STAFF REPORT
COMMUNITY DEVELOPMENT DEPARTMENT

HEARING DATE: 5/25/2021
 TO: Mayor & City Council
 FROM: Joe Dodson, Associate Planner
 208-884-5533
 SUBJECT: H-2020-0122
 3175 N. Ten Mile Rezone

LOCATION: The site is located at 3175 N. Ten Mile Road, the southwest corner of the Ten Mile and Ustick Road intersection, in the NE ¼ of the NE ¼ of Section 3, Township 3N., Range 1W.

C. Conceptual Building Elevations

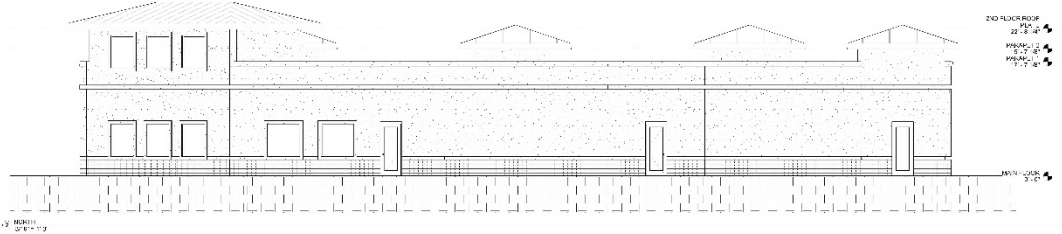
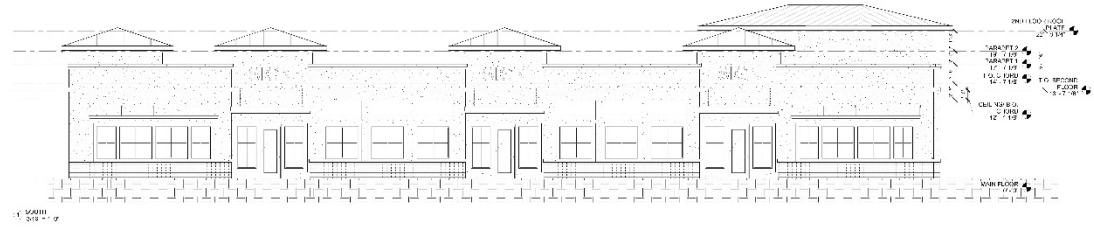
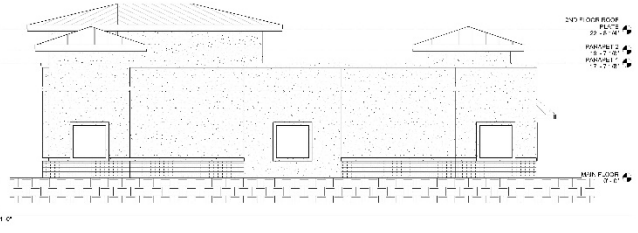
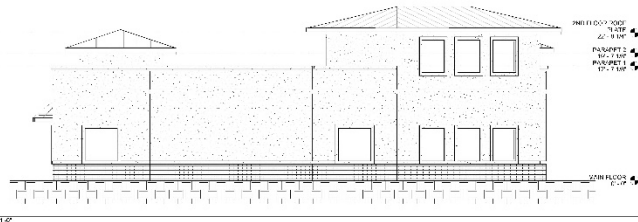
The Applicant submitted conceptual building elevations of the proposed single-story commercial building. The submitted elevations show a single story building approximately 22' to top of plate in the area of the building that directly abuts the intersection; this area is meant to hold the corner of this intersection. The remaining portions of the building are approximately 17.5' in height. Overall the building is shown with varying parapet heights, a stone material banding along the bottom of the building, horizontal wall modulation, and a main field material that appears to be stucco. The south facing elevation also shows awnings and windows nearly the length of the building lending itself to a modern storefront feel.

New commercial buildings require Administrative Design Review prior to building permit submittal so Staff will perform a more complete analysis of the proposed elevations at the time of that application submittal. Staff recommends the north facing elevation incorporate an additional field material to satisfy one or more of the architectural standards.
